ADDENDUM NUMBER 1

DATE: 12/20/2024

PROJECT: SEMCO Emergency Operations Center

ARCHITECT/ENGINEER: Anderson, Eckstein & Westrick, Inc.

E101

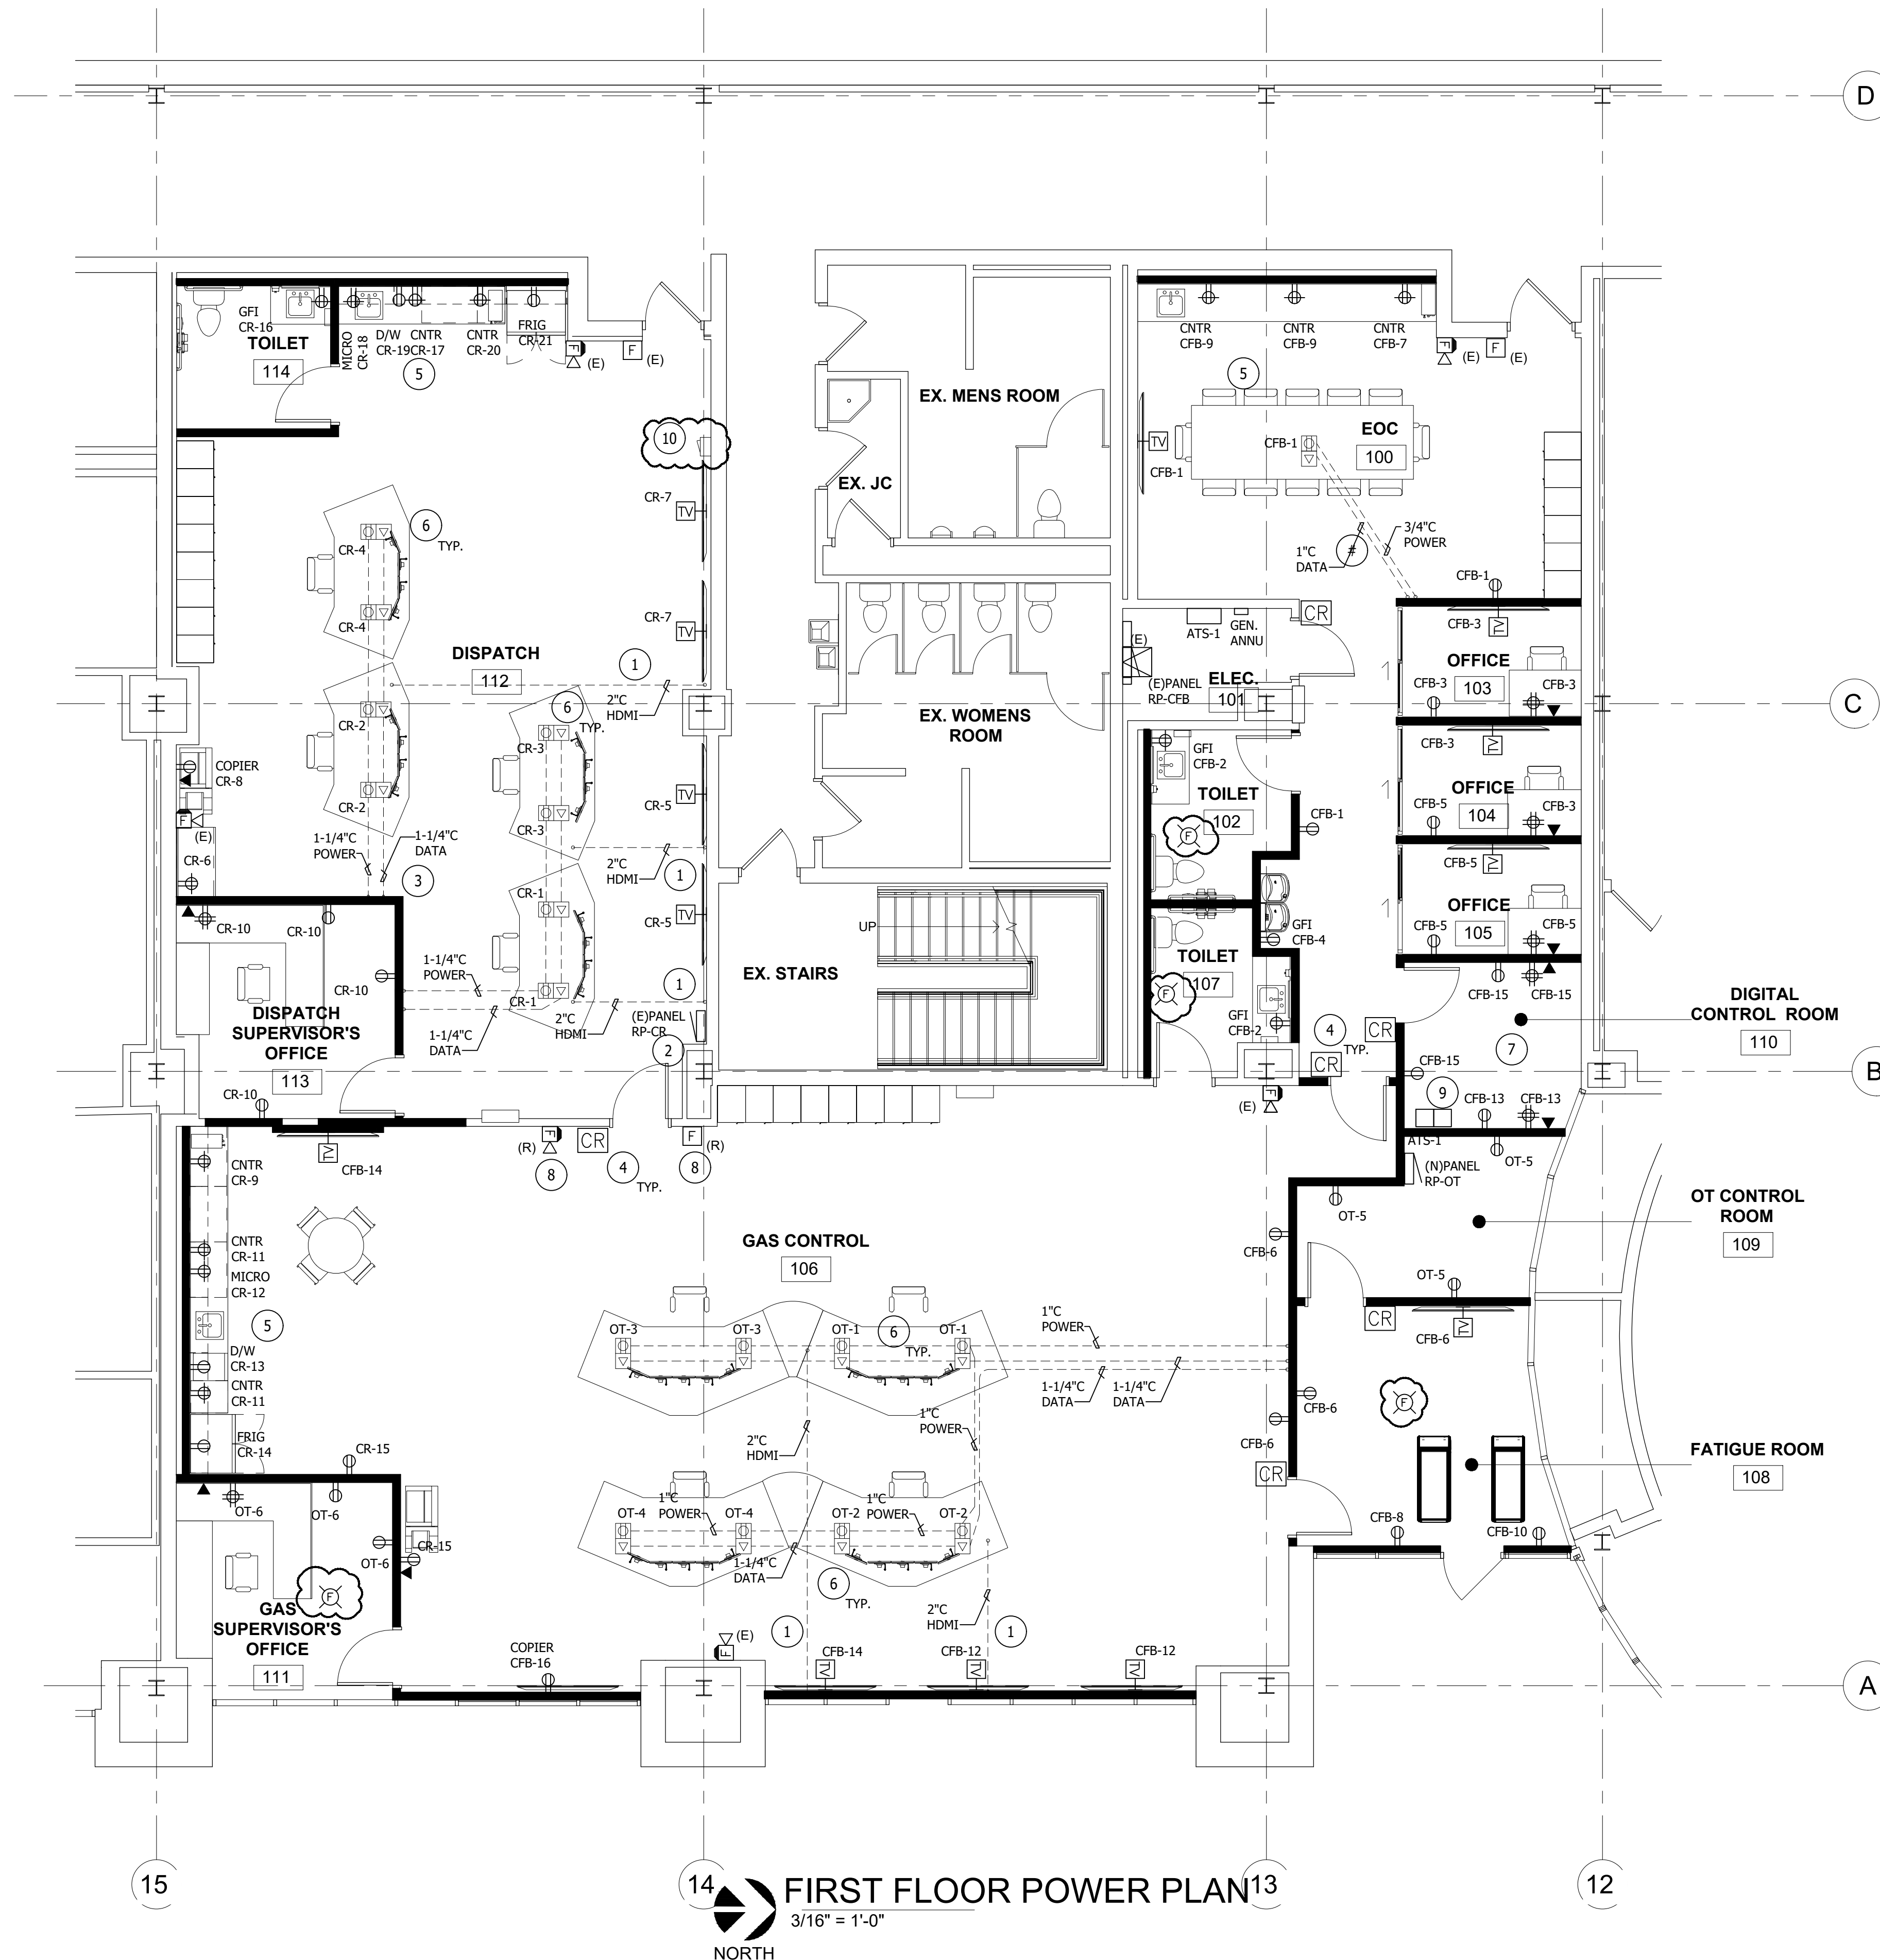
7. **Q:** Please provide further information regarding the fire alarm system, the spec section is not included in the bid documents.
A: No specification is required since we are using the existing system. Refer to added Keyed Note 10 on E101.

11. **Q:** Please provide the current fire alarm manufacturer in use.
A: Refer sheet E101, added New Work Key Note 10. Fire Alarm manufacturer is unknown at this time, provide allowance.

12. **Q:** Per page E101, please clarify fire devices for rooms 102/3/4/5, 107 and 111.
A: Refer to sheet E101 for revised fire devices needed.
13. **Q:** Per page A101, please clarify wall types for rooms 103/4/5, 108,109 and 111
A: All walls not labeled are wall type A, refer to partition type legend.

1. SHEET E101
 - a. Added New Work Keyed Notes 10
 - b. Added Fire devices
2. SHEET E103: reissued
 - a. North arrow revised

7	VERIFY EXACT MOUNTING HEIGHT OF ALL OUTLETS IN THIS ROOM WITH IT CONTRACTOR PRIOR TO ROUGH-IN.
8	EXISTING FIRE ALARM DEVICE TO BE RELOCATED TO THIS WALL, REFER TO DEMOLITION PLAN FOR ORIGINAL LOCATION.
9	PROPOSED LOCATION OF (2) 20KVA UPS SYSTEMS. ONE 20KVA UPS TO BE PROVIDED BY OWNER, OTHER TO BE PROVIDED BY ELECTRICAL CONTRACTOR. CONTRACTOR TO PROVIDE ALL CONNECTIONS. NEW UPS SHALL MATCH EXISTING COORDINATE WITH OWNER ORDER TO PURCHASE.
10	EXISTING FIRE ALARM NAC PANEL BY "NATIONAL TIME AND SIGNAL 900 SERIES" TO BE USED FOR CONNECTION OF ADDITIONAL STROBE DEVICES IN ROOMS 102, 107, 108 AND 111. NEW DEVICES SHALL MATCH COLOR OF EXISTING DEVICES.

REFERENCE A

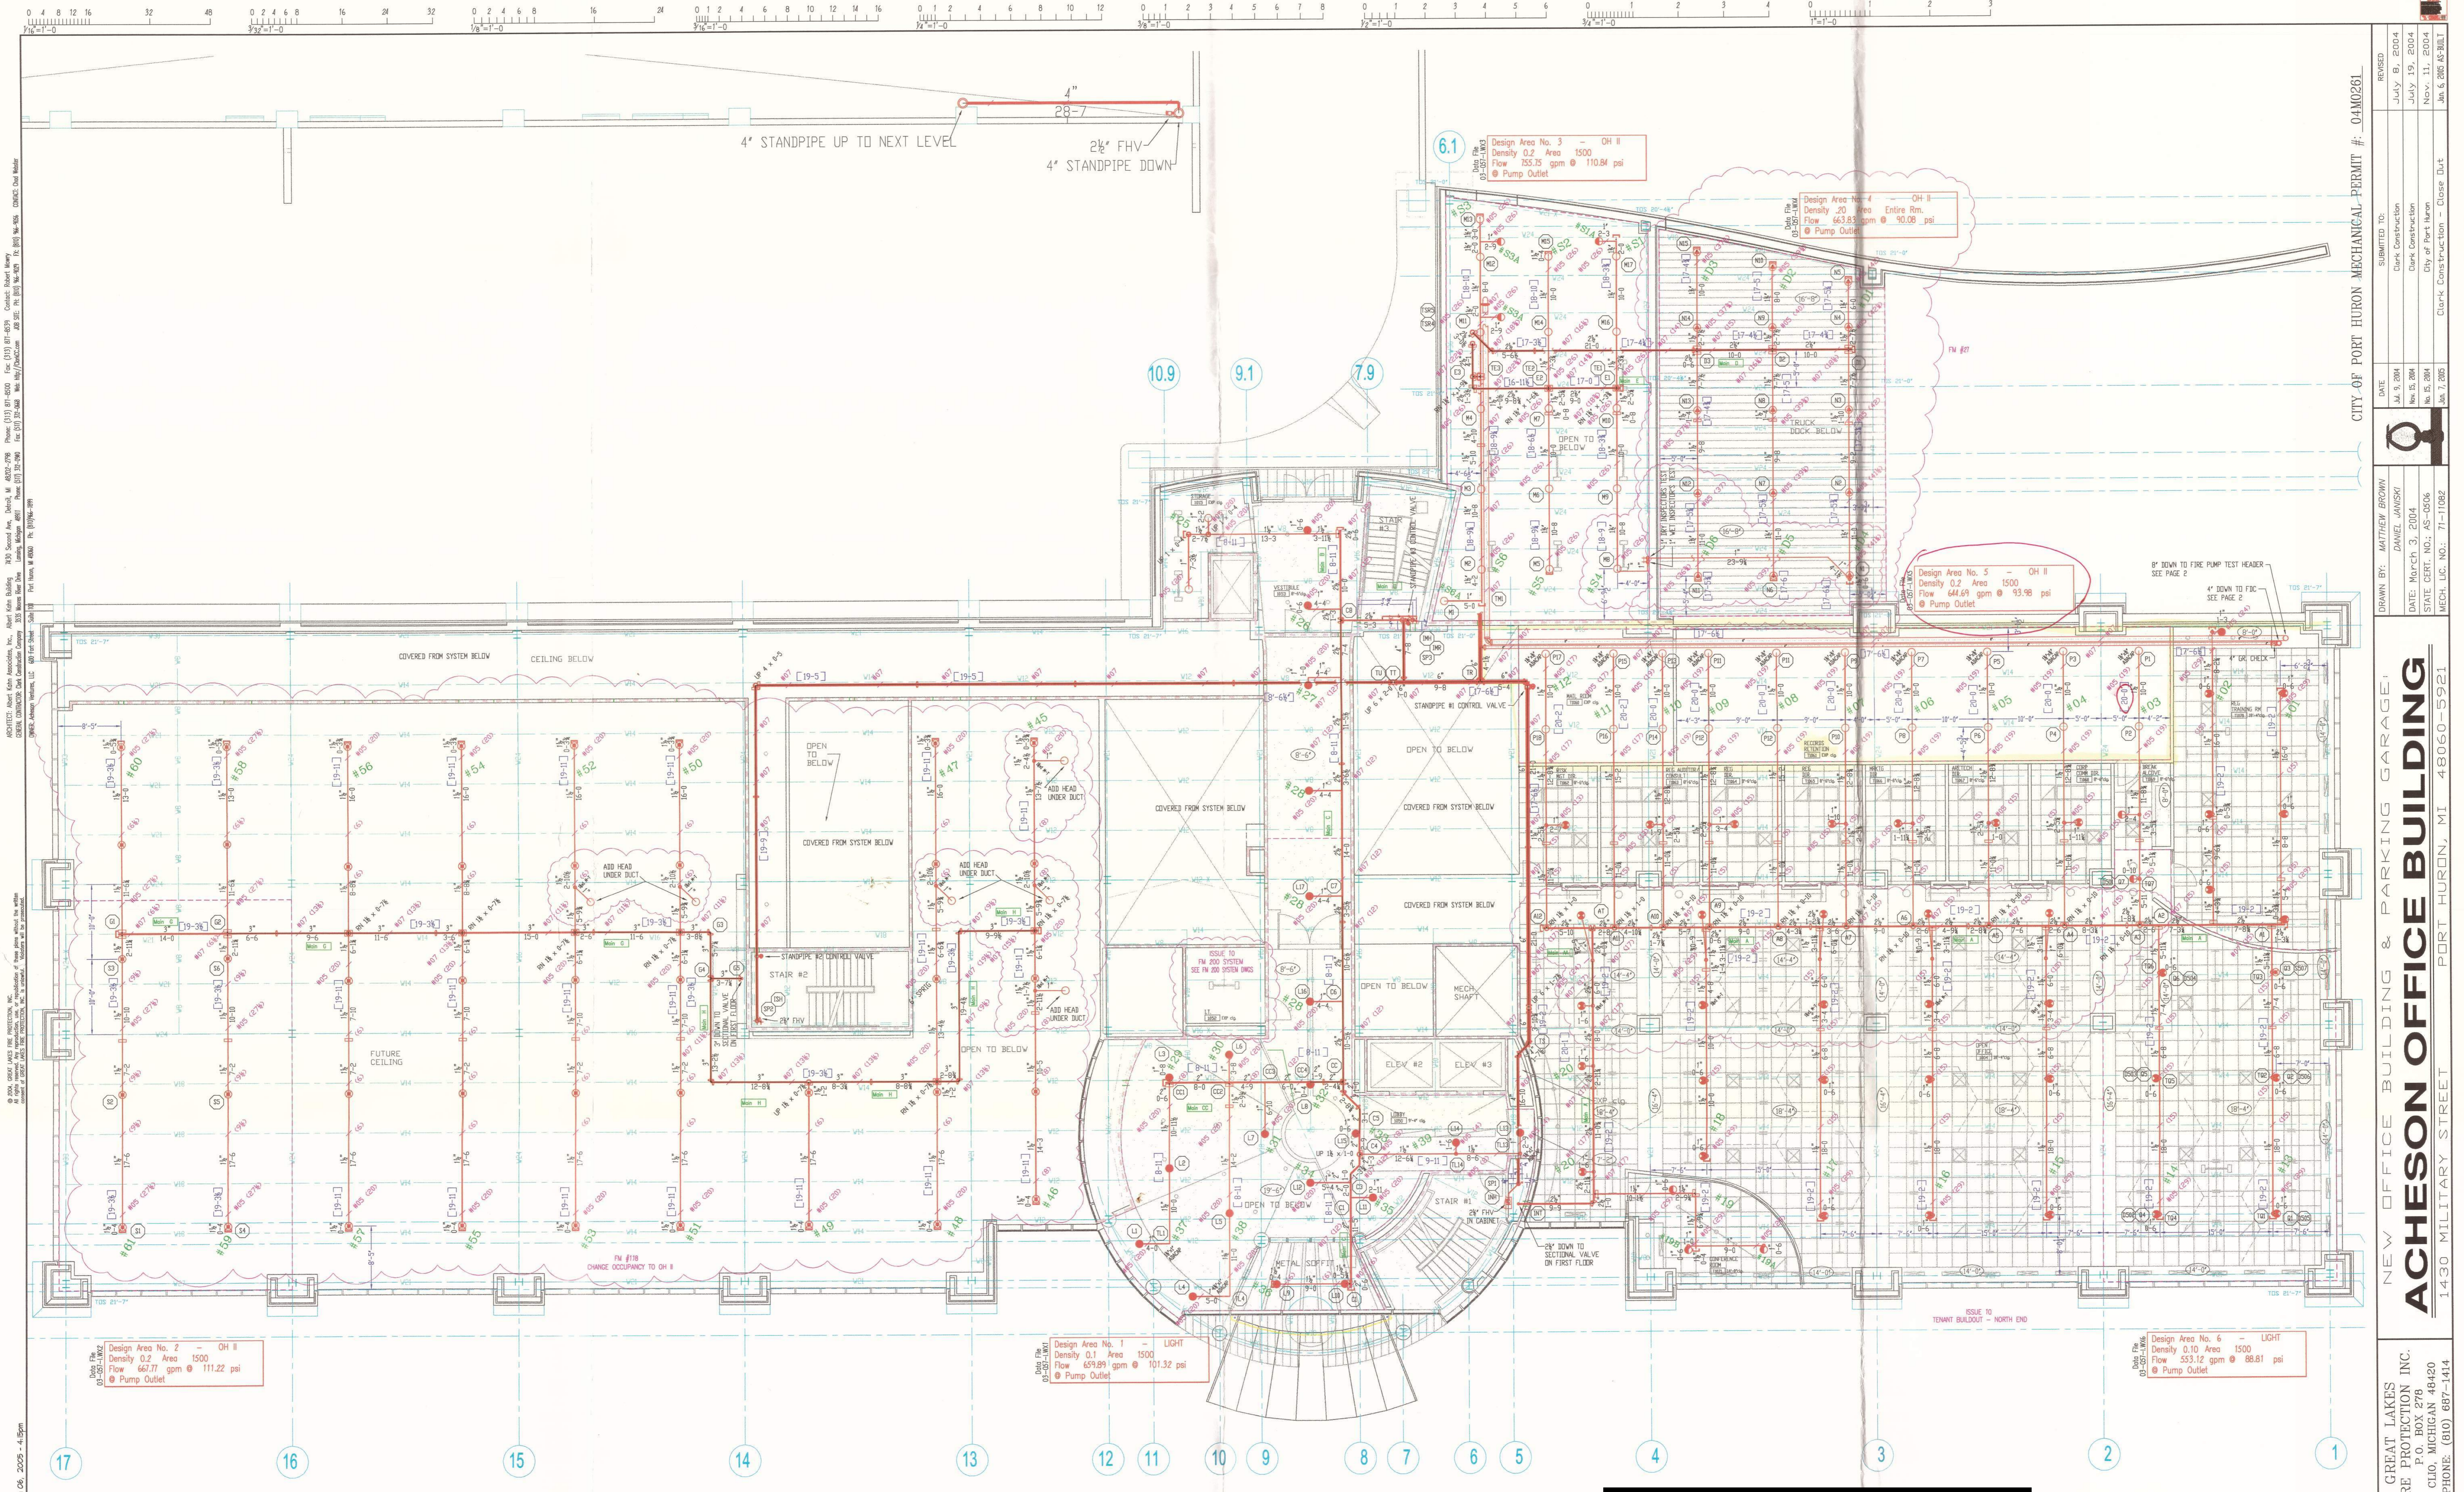
6. **Q:** Please provide further information regarding the fire suppression system, the drawing was not included in bid set
A: Refer to M011 for added Fire Protection Specification and added Reference A for existing fire suppression drawings, verify sprinkler heads in field.
